**CITY OF LINO LAKES
PLANNING & ZONING BOARD MEETING**

REQUEST: **CONTINUED PUBLIC HEARING** for Love to Grow On (6499 Lakota Trail)
 1. Conditional Use Permit
 2. Site Plan Review
 3. Variances

Re: *Love to Grow On - Resubmittal*
CUP, Variance and Site Plan Review
WSB Project No. 011428-000

A100

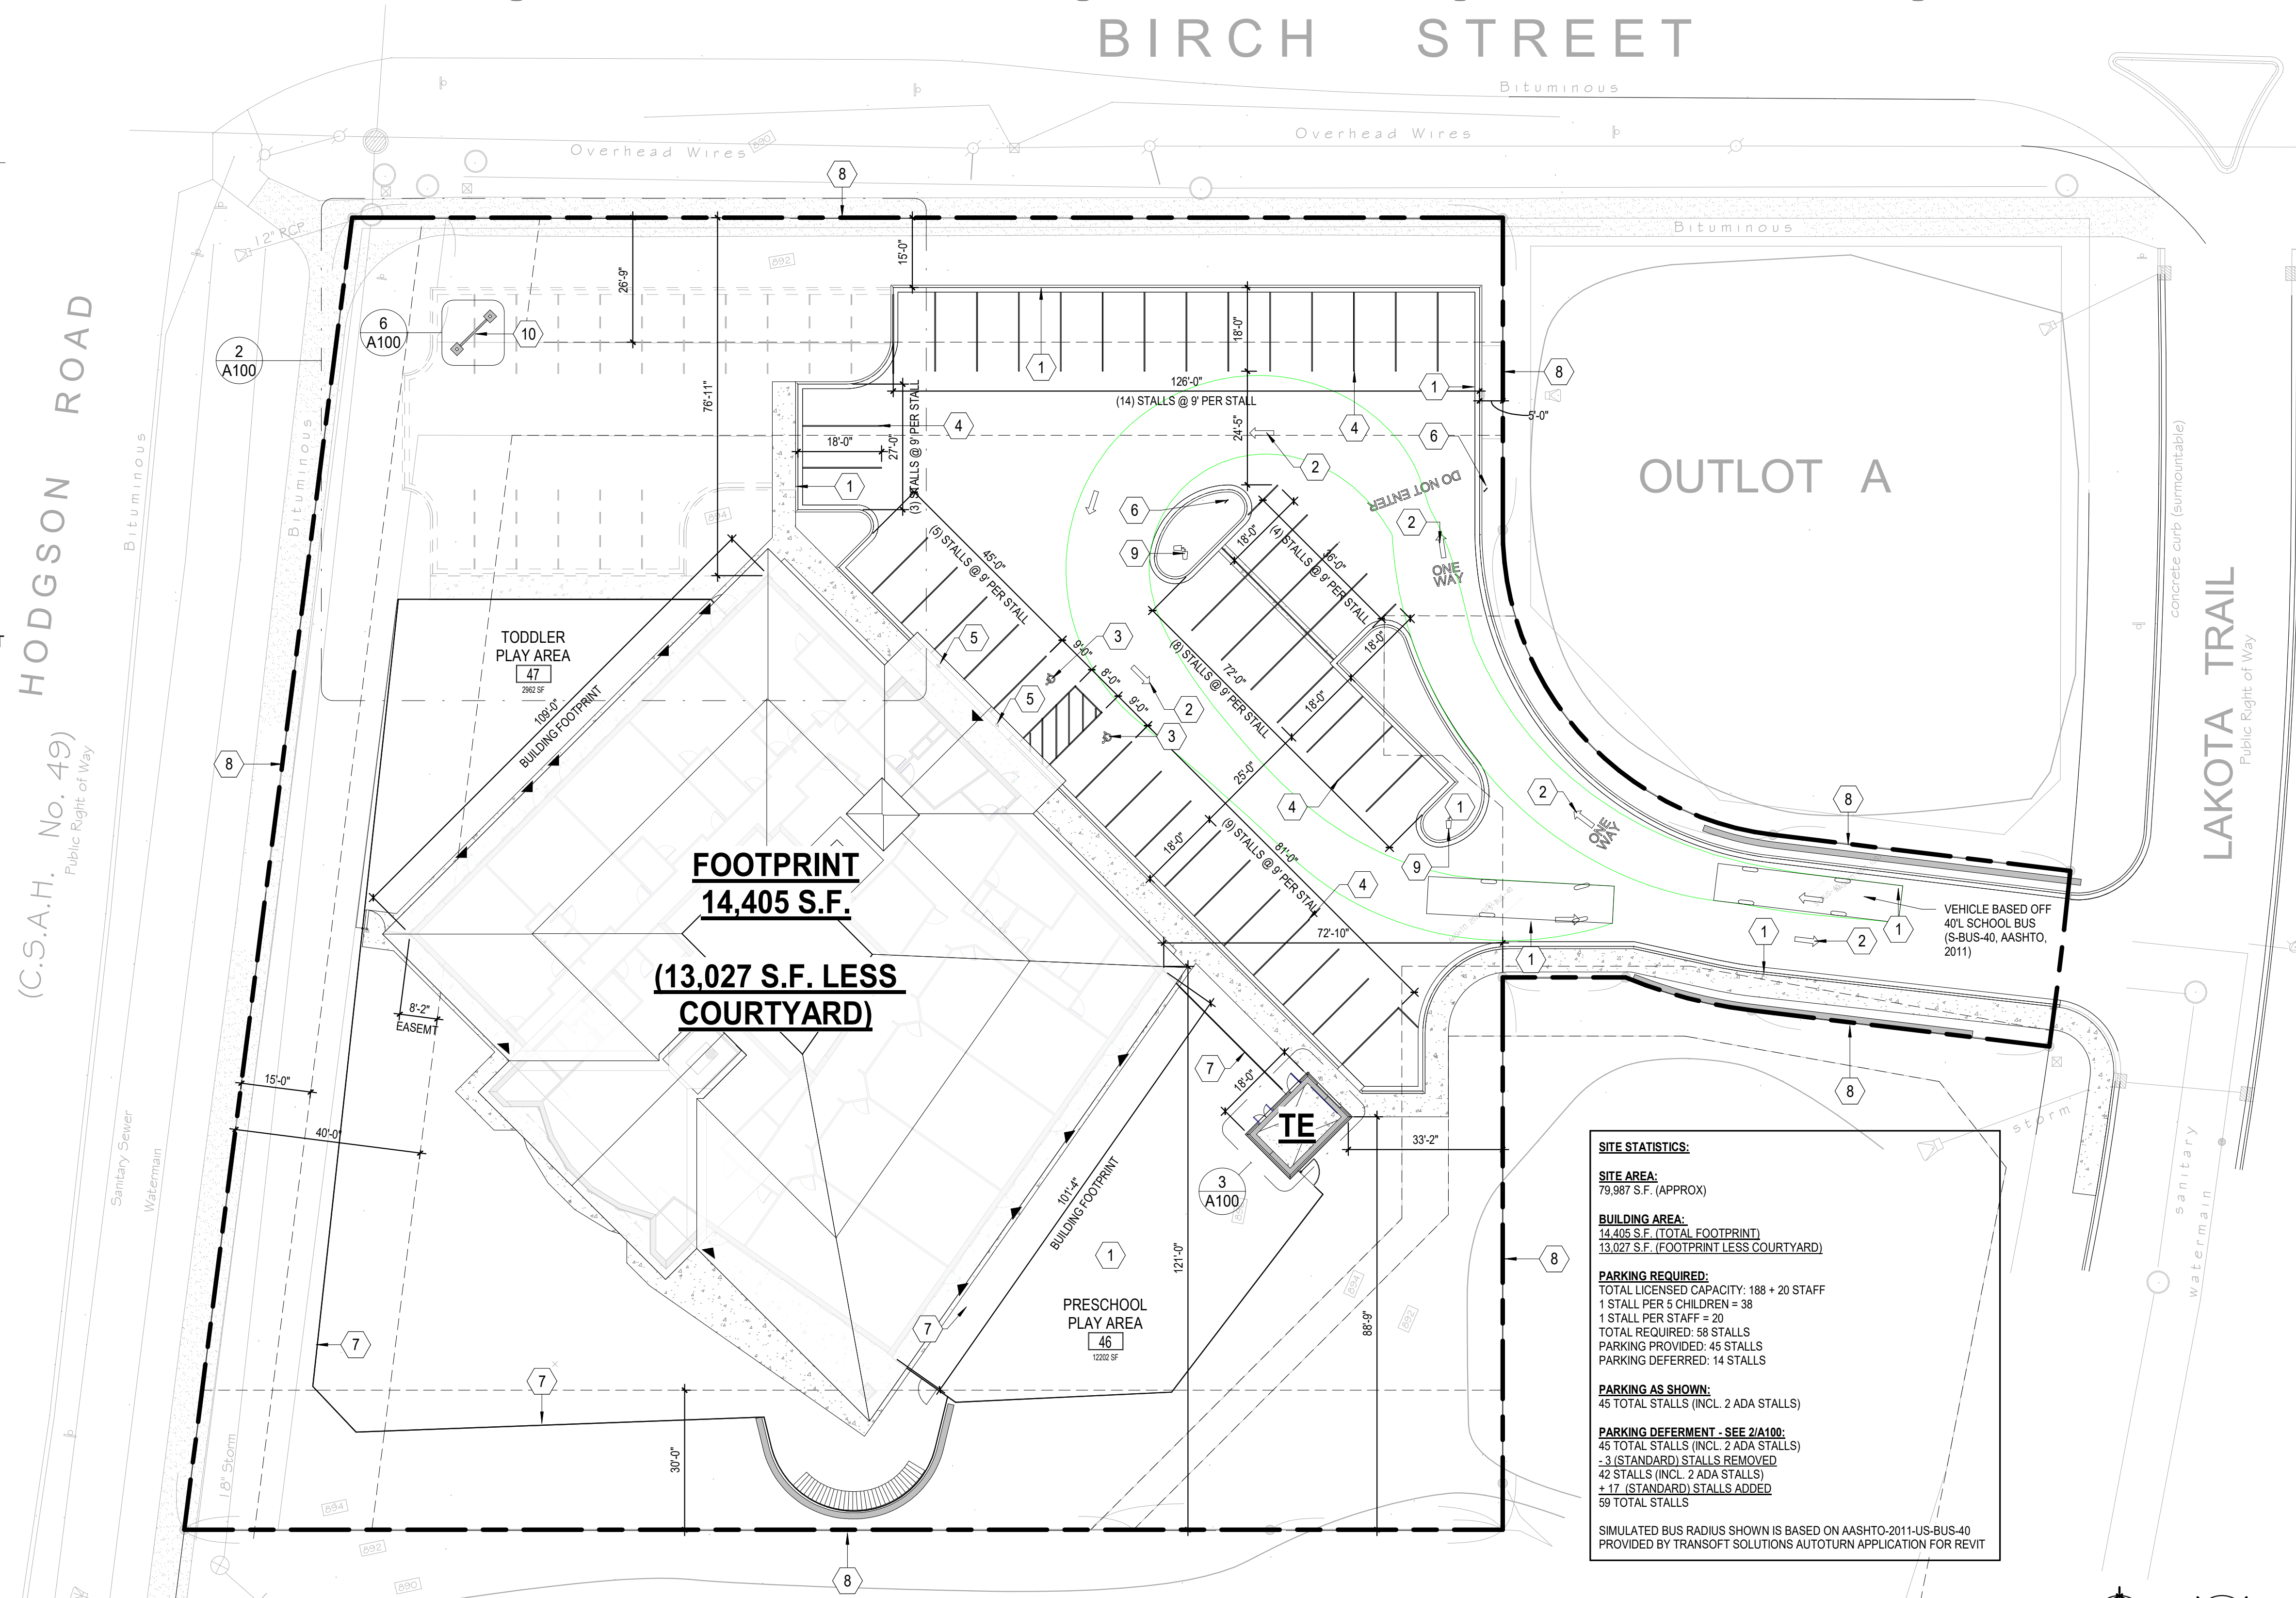
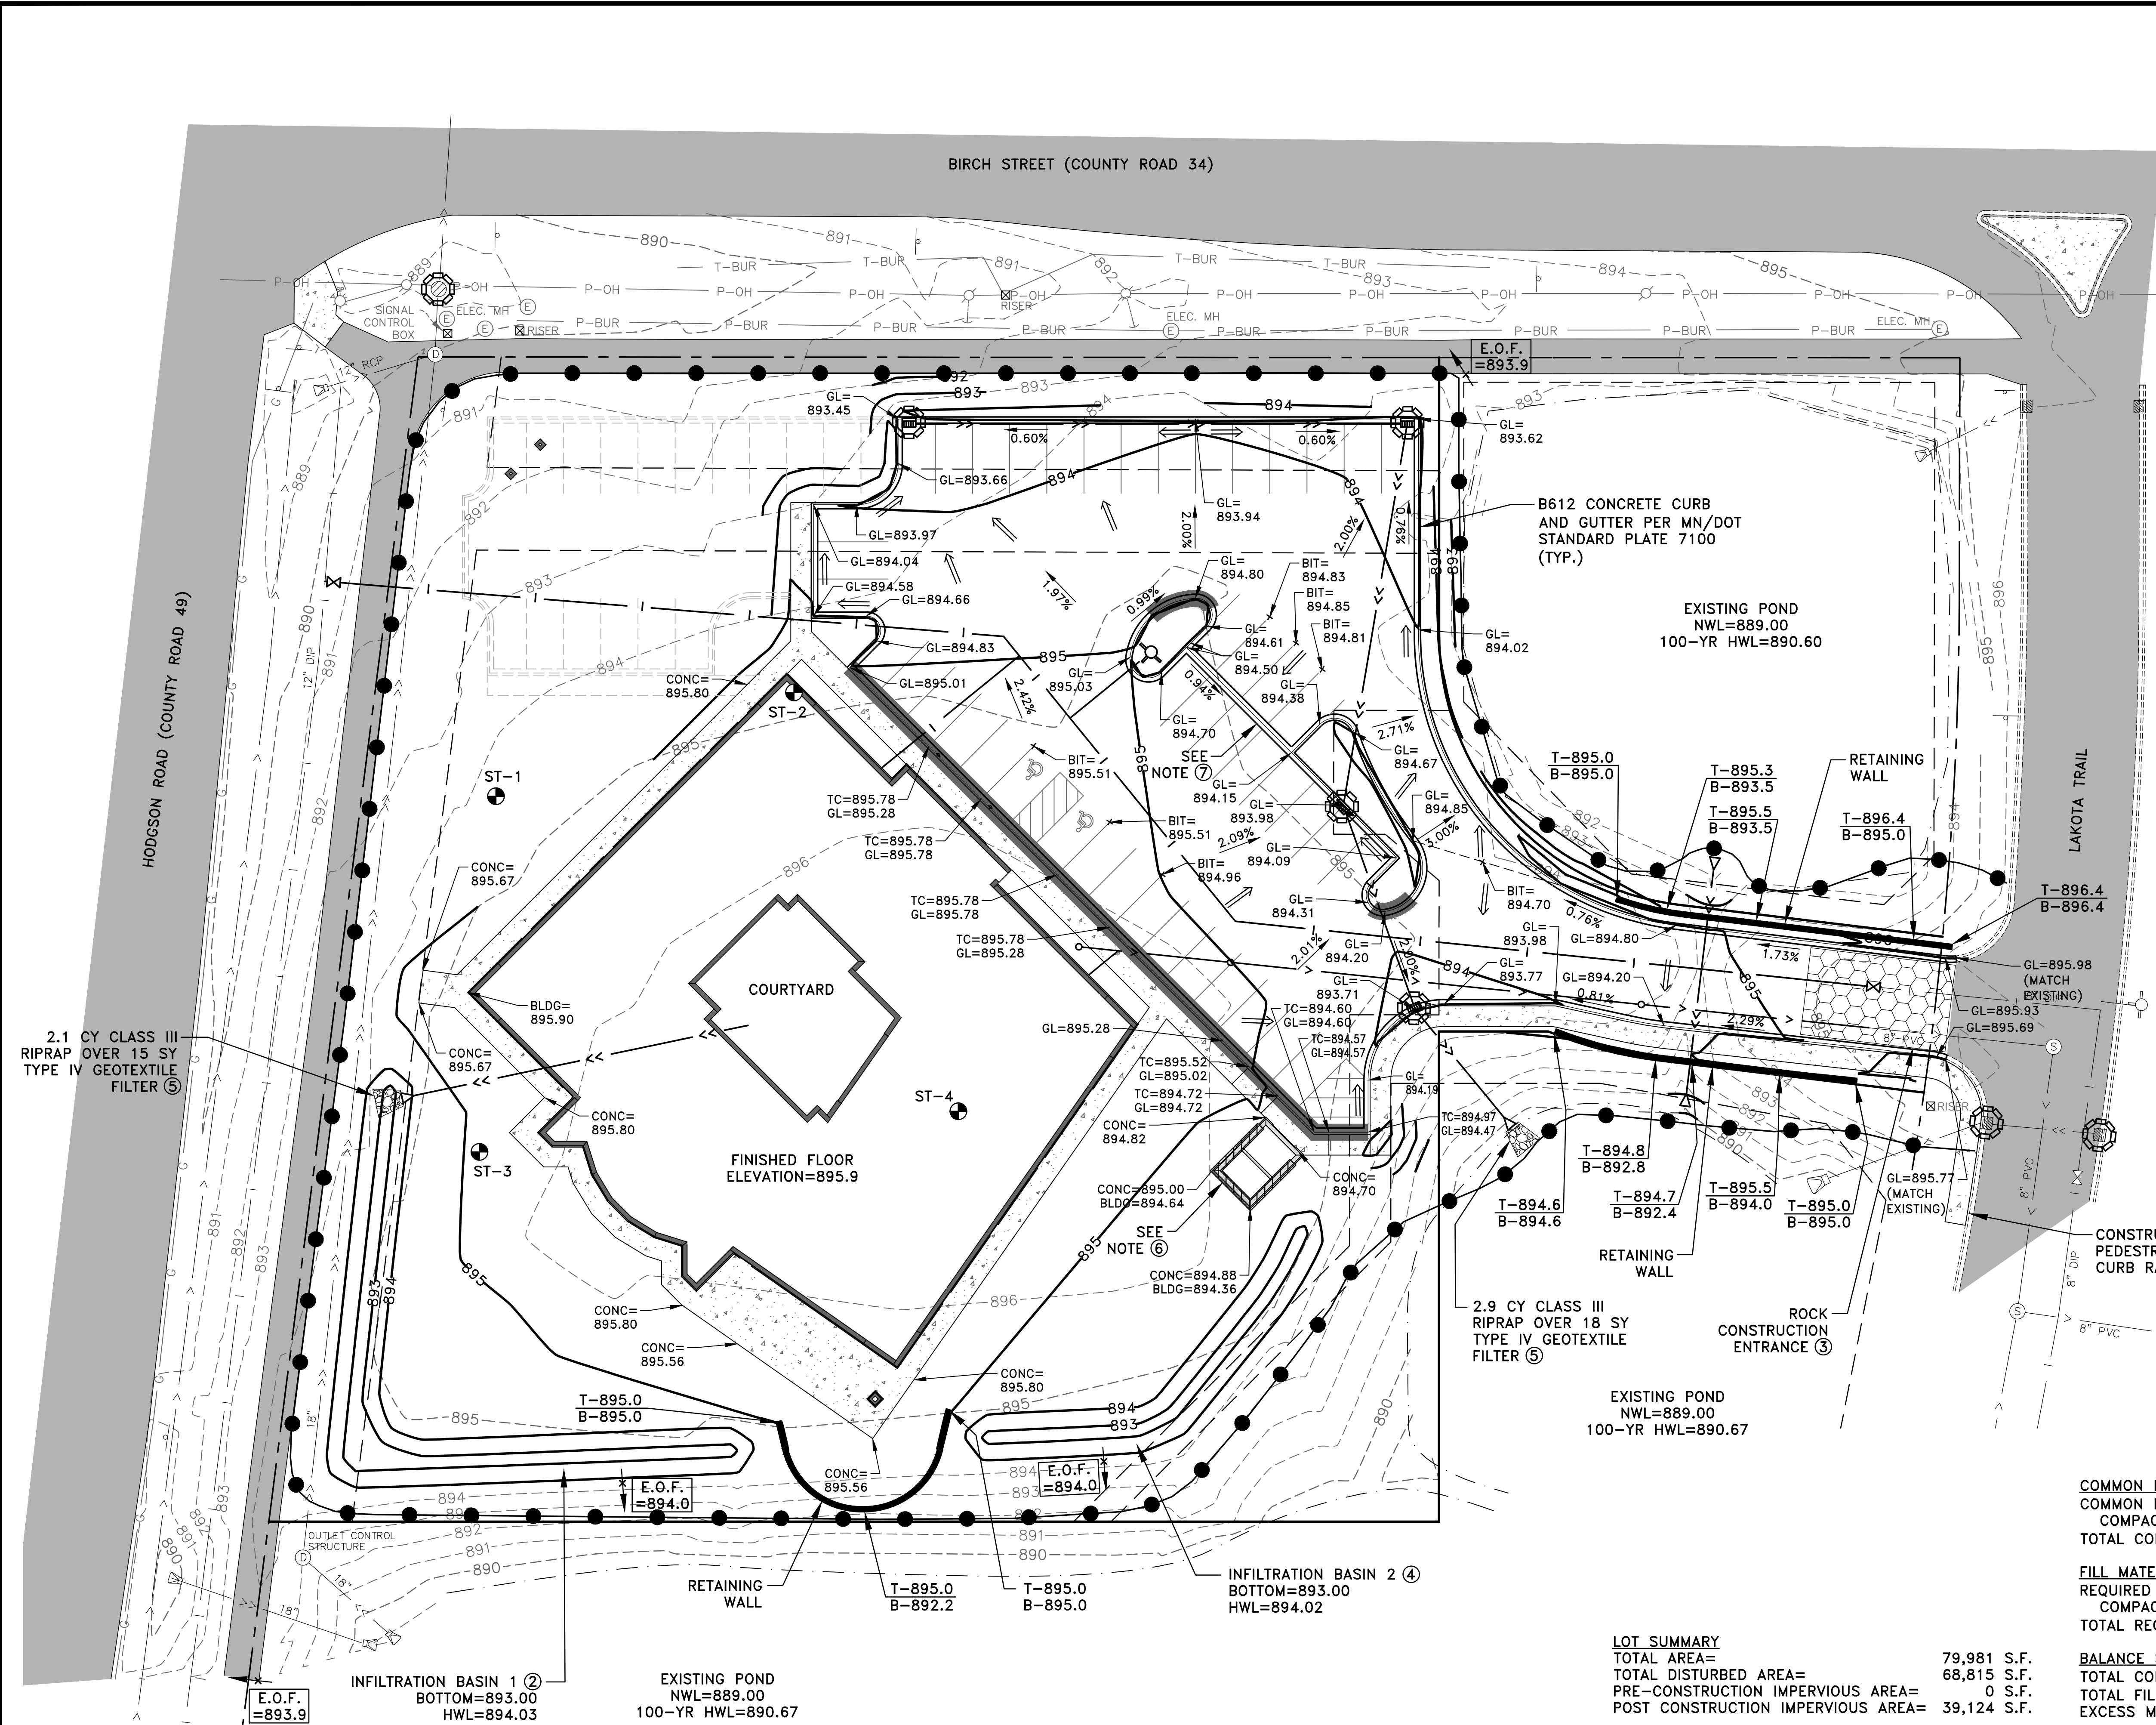
1. The 8' 2" Easem note shall be revised to 9'0" Variance.
2. Plan shall note 4" parking stall striping is required.

1. The narrative describes a 9'-0" encroachment but Sheet A1, Site Plan indicates an 8'-4" encroachment.
 - a. Please revise Sheet A1, Site Plan accordingly.

- a. Omit the word PUD under Revision Submittal.
7. Sheet A100: Site Plan:
 - a. The note that says 8' 2" Easem shall be revised to 9'0" Variance.
 - b. Plan shall note 4" parking stall striping is required.
8. Sheet L.1, Preliminary Landscape Plan:
 - a. Additional trees are required to meet canopy cover requirements.
